**PLAN COMMISSION MEETING
IN PERSON AND VIA ZOOM
TUESDAY, APRIL 14, 2026 – 4:00 PM
CITY HALL – SECOND FLOOR**

AGENDA

SITE PLAN REVIEW REPORT TO THE PLAN COMMISSION

CERTIFIED SURVEY MAP REPORT TO THE PLAN COMMISSION

PROJECT NO: 241369
SHEET NO: 1 of 5

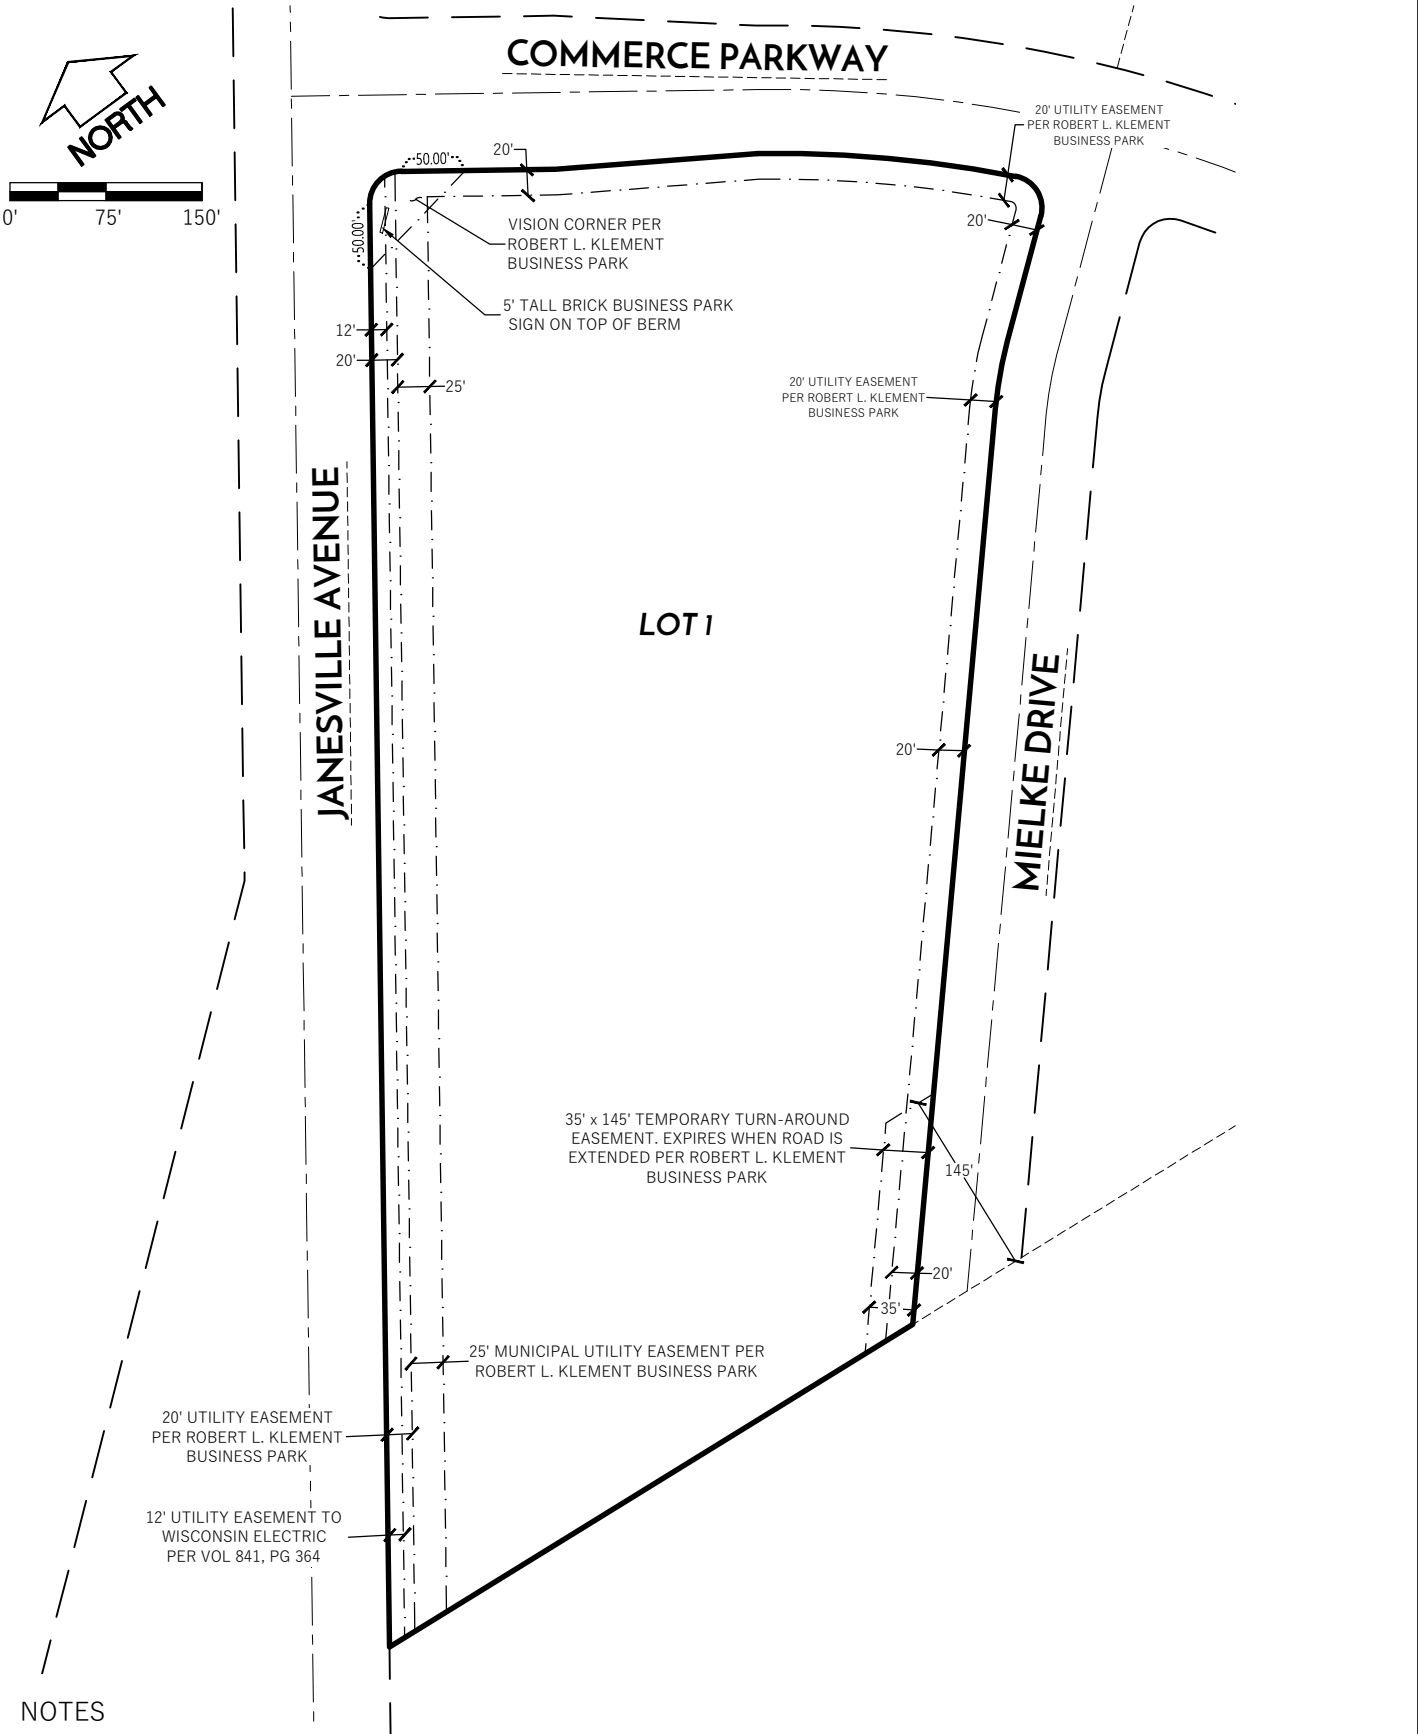
s. 236.34(1m)(a) Each sheet of the final CSM must be signed, sealed and dated by a WI Professional Land Surveyor.

s. 70.06.01(1)(b) Contact information. Name, mailing address, email address, and phone number of the owner, developer and land surveyor. Add the underlined information to the final CSM.

s. 70.06.01(1)(d) Inset Map. An inset map of the area showing the general location of the proposed subdivision in relation to U.S. Public Land Survey section and quarter-section lines and abutting and nearby public streets and highways. The inset map shall be oriented on the sheet in the same direction as the main drawing. An inset map shall be added to the final CSM. In Note 1. verify the field work completion date. It is shown as August 12th and 14th, 2026. In line 2 remove the phrase “in accordance with the information provided” in lines 3 and 4.

City staff recommends the Plan Commission recommend the City Council approve the Certified Survey Map, subject to the following conditions:

FORT ATKINSON INDUSTRIAL BUILDING

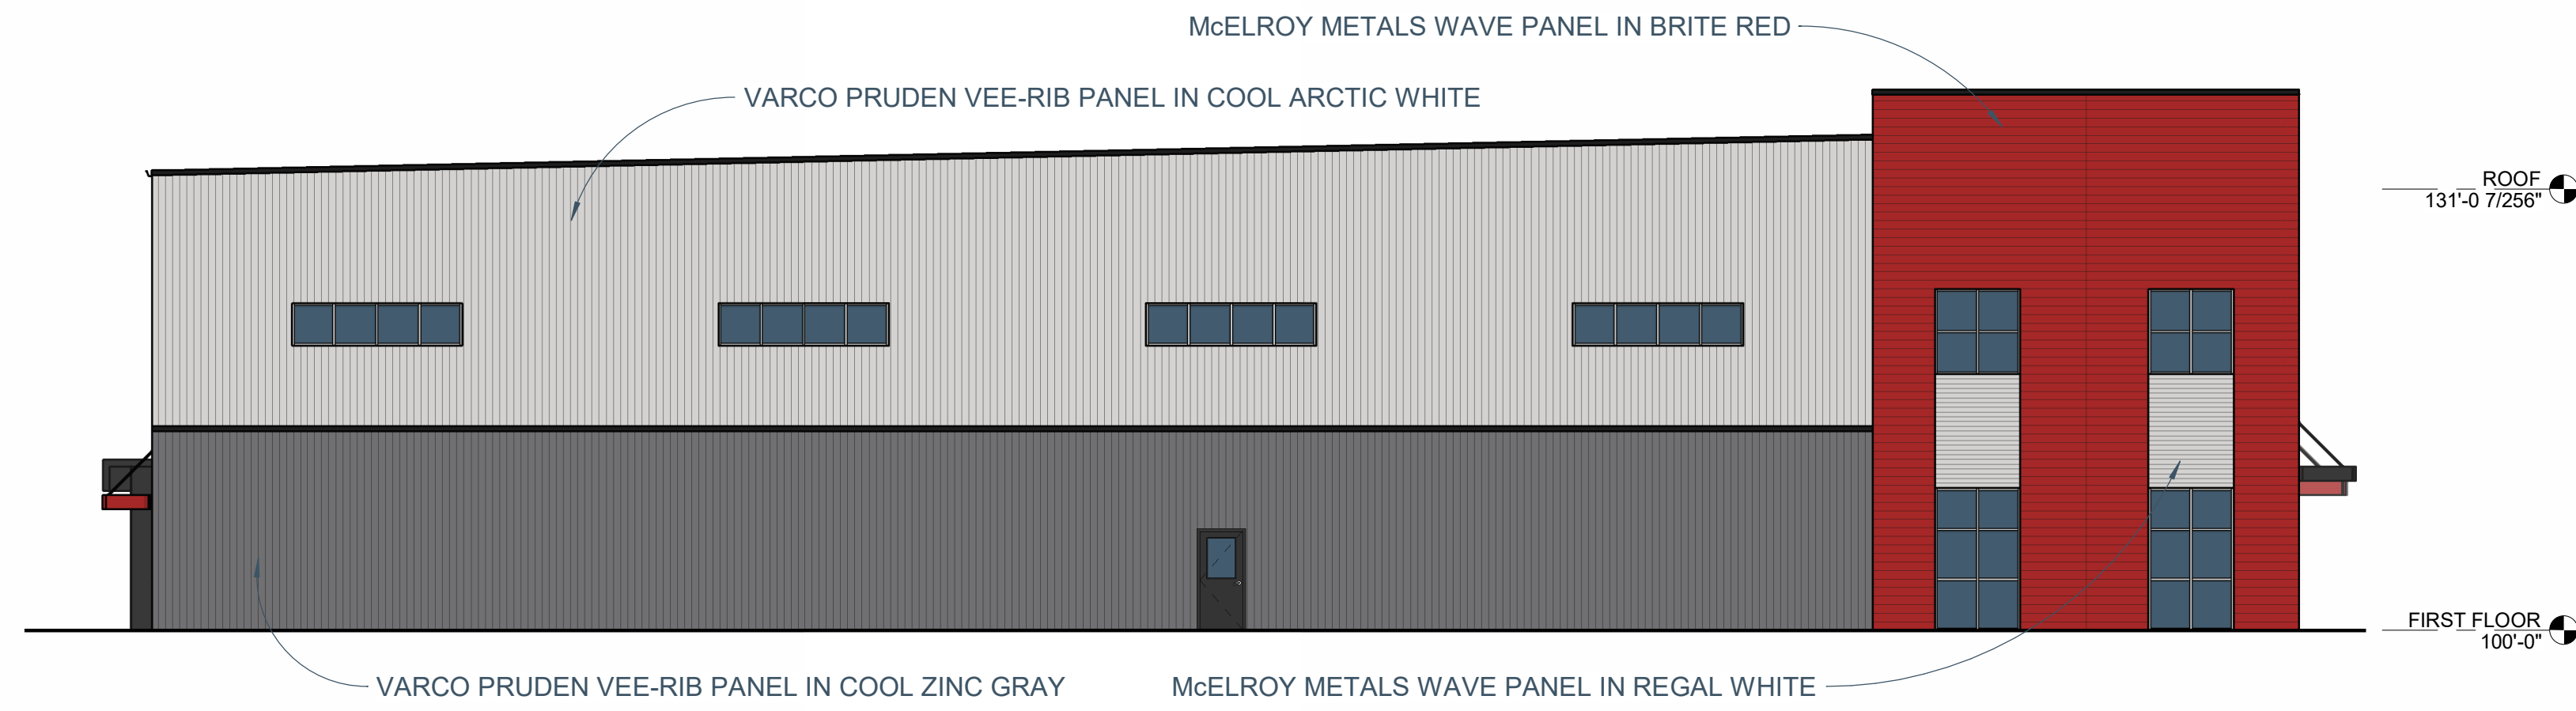
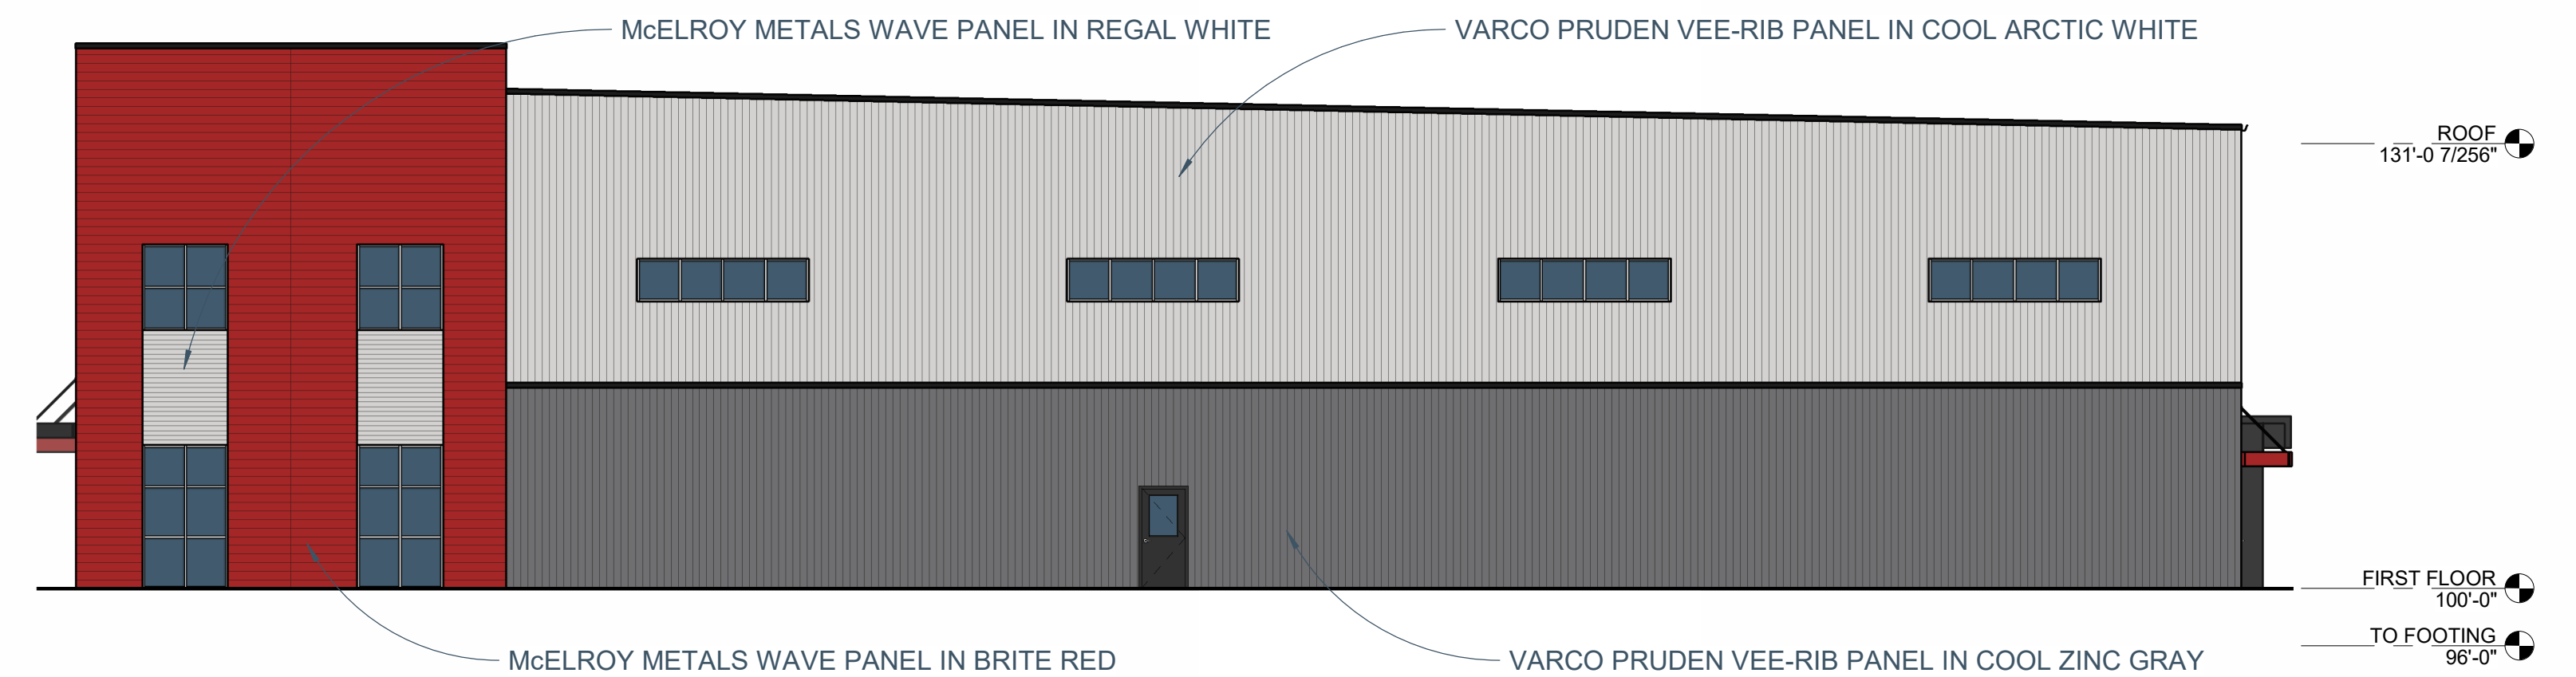
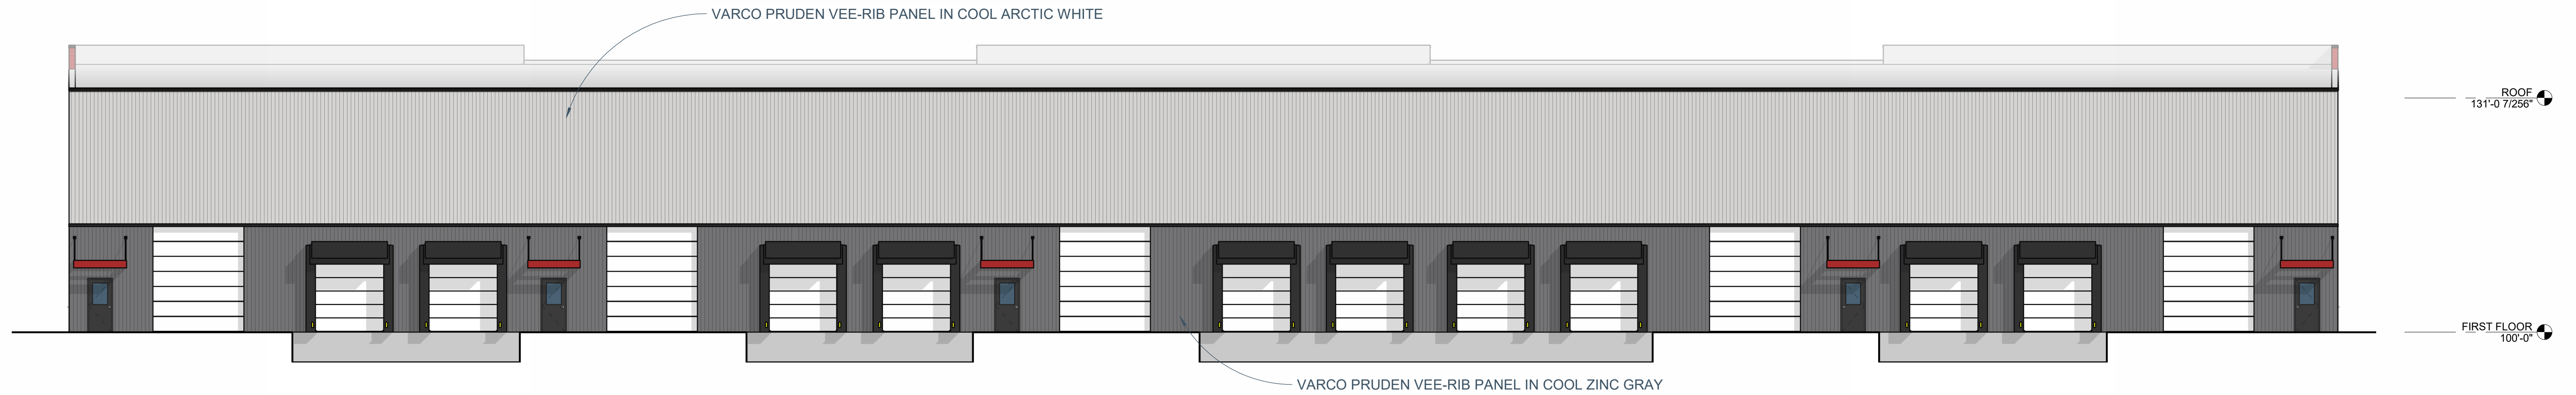
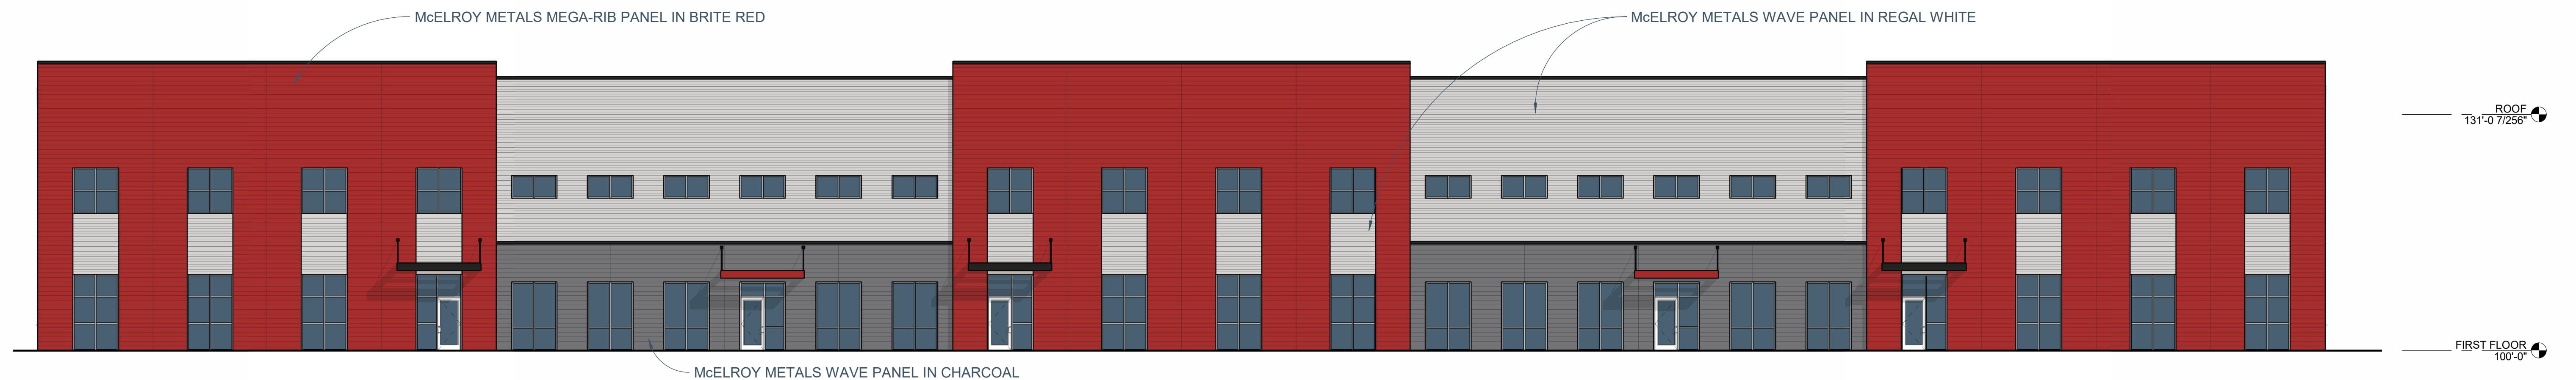
Given these variations, staff recommends that the Plan Commission evaluate the buildings holistically. When averaged, the Class I material coverage across the west (Janesville Avenue) and north (Commerce Parkway) façade meets the 15% requirement for each frontage. However, the east façade remains noncompliant.

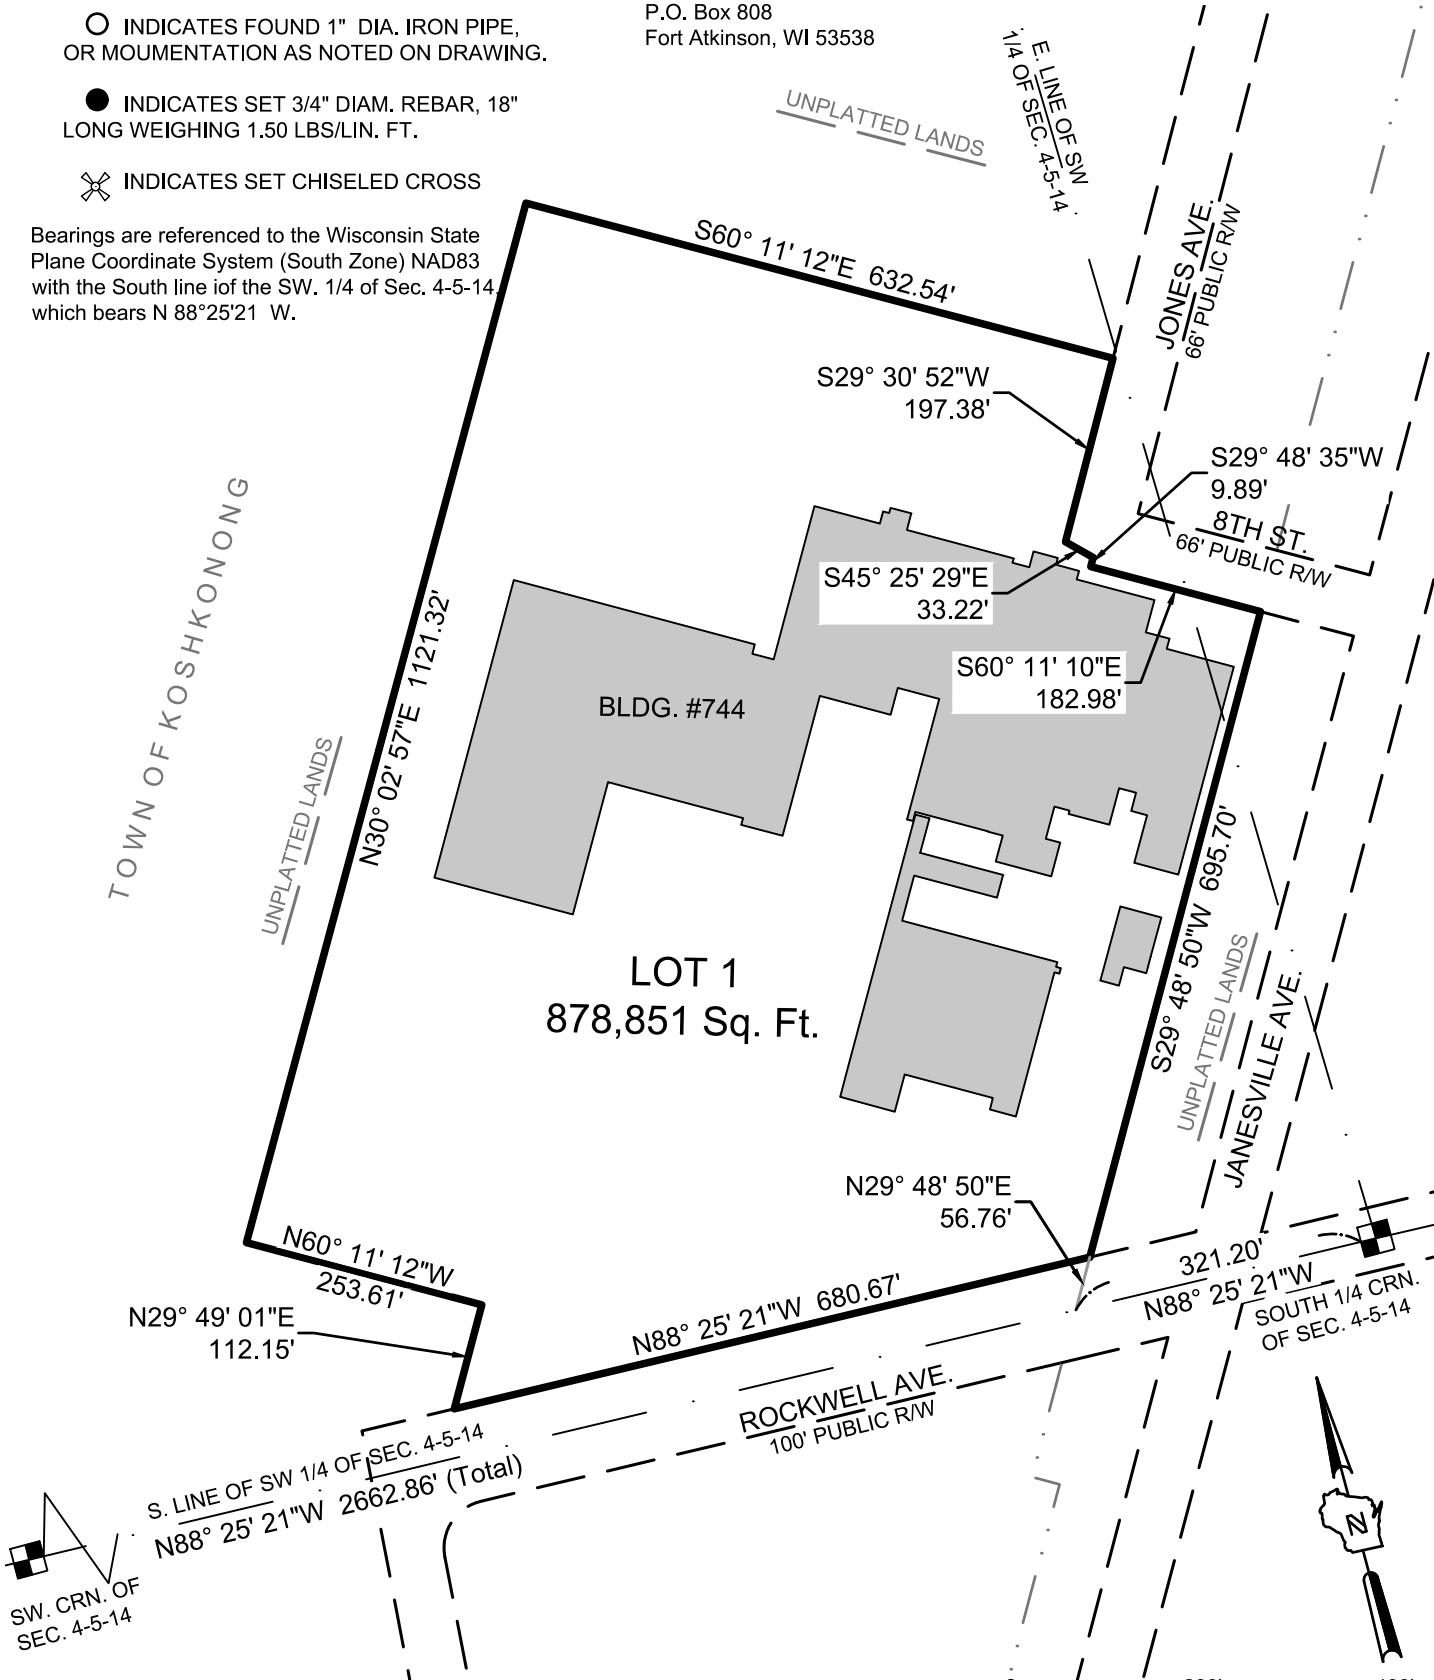
s. 236.15(1) Monuments: *On the final CSM, show set/found corners at each of the lot corners.*

- 1) Some of the text is cut off near the top of Sheet 1 on the quarter section line.*
- 2) Show the total sheet numbers on the final CSM.*
- 3) The bearing on the 56.76' long tie line is different in the Surveyor's Certificate than on the map.*
- 4) The bearing in the Surveyor's Certificate that goes with the 112.15' length is missing an "E."*
- 5) Towards the end of the Surveyor's Certificate, the course with the 197.38' length is repeated and the 33.22' long course is missing.*
- 6) Add the Owner's Certificate and City of Fort Atkinson Approval Certificate on the final CSM.*

Staff recommends the Plan Commission recommend the City Council approve the Certified Survey Map with the following conditions:
